**Re: Response to Transportation Comments
48 Grenoble Drive
City File: 22 127125 NNY 16 OZ/ 22 137124 NNY 16 SA
Project No.: 300054545.0000**

R.J. Burnside & Associates Limited (Burnside) has reviewed the City of Toronto's (the City) transportation related comments within the Engineering & Construction Services Memorandum, dated May 25, 2022, and City Planning Division North York District letter, dated September 2, 2022.

N.T.S

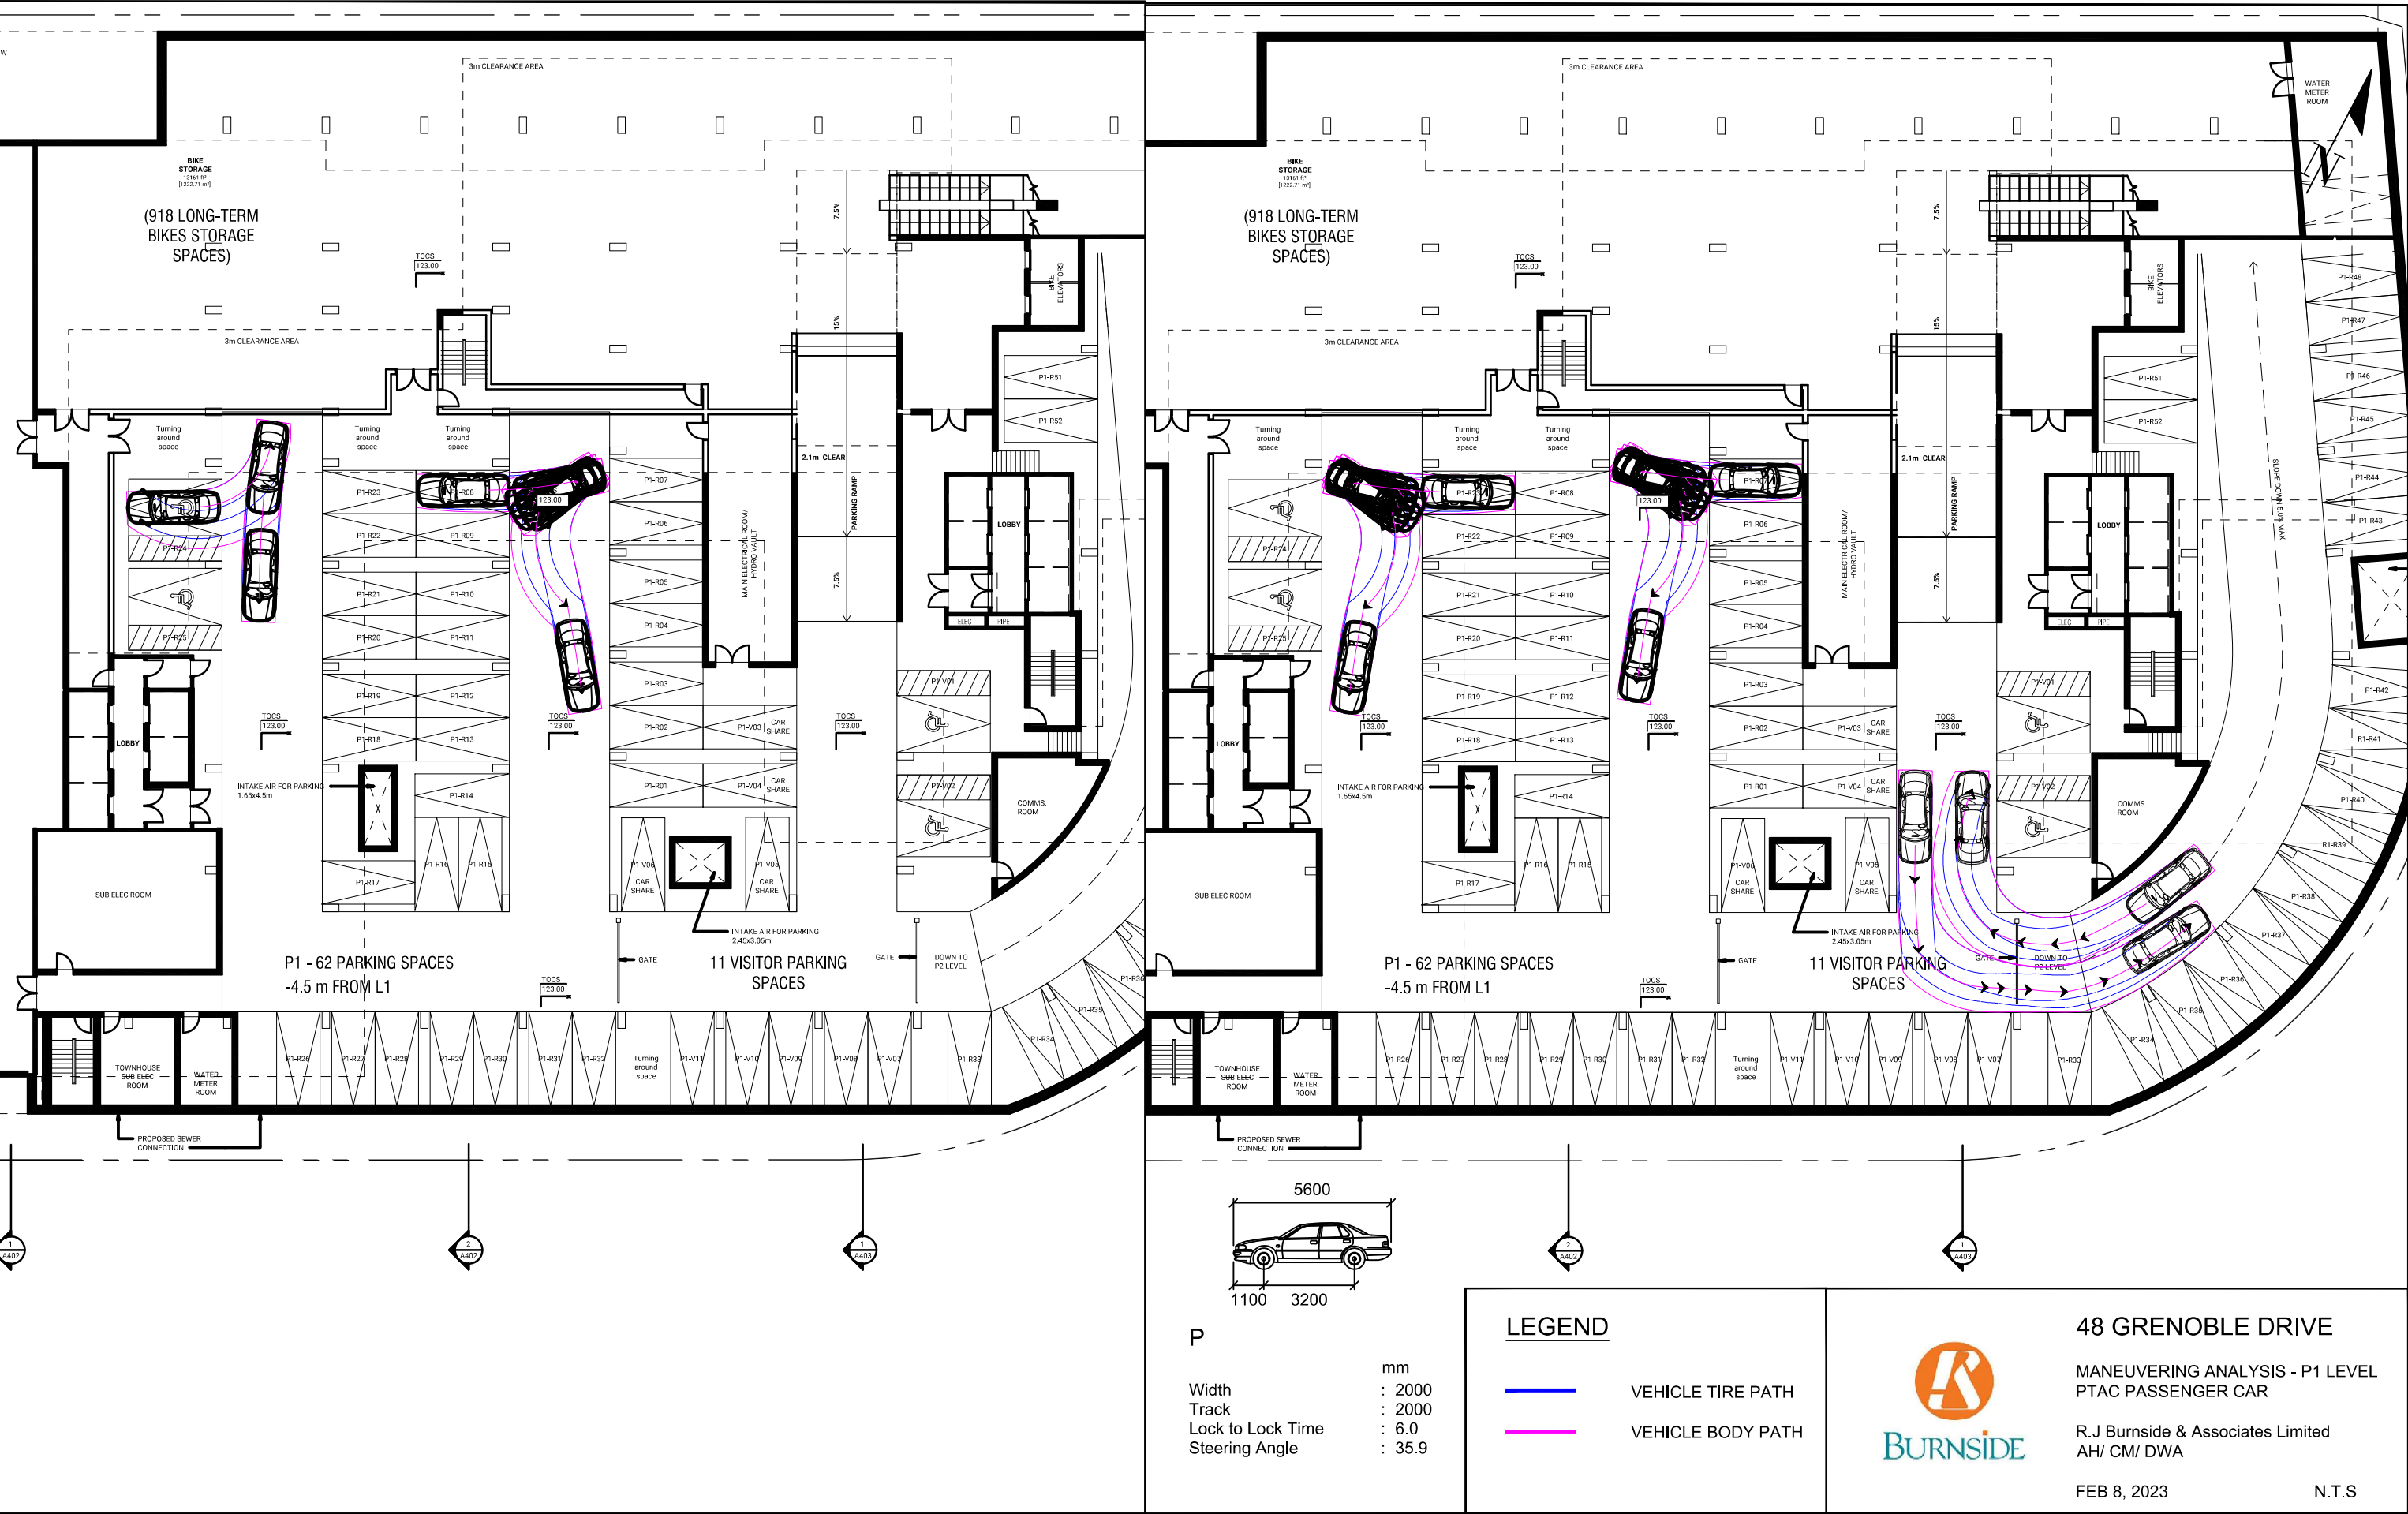
1.2.6. Revised drawings must indicate and annotate a collection vehicle movement diagram that has a length of 12 metres and a width of 2.4 metres with a minimum inside/outside turning radii of 9.5 metres and 14 metres respectively, when entering, exiting, travelling throughout the site and entering/exiting the type G loading space. The diagram must also indicate the ability of the collection vehicle to enter and exit the site in a forward motion with no more than a three-point turn.

Updated collection vehicle movement diagrams are provided in Attachment 3, which satisfies the requirements noted.
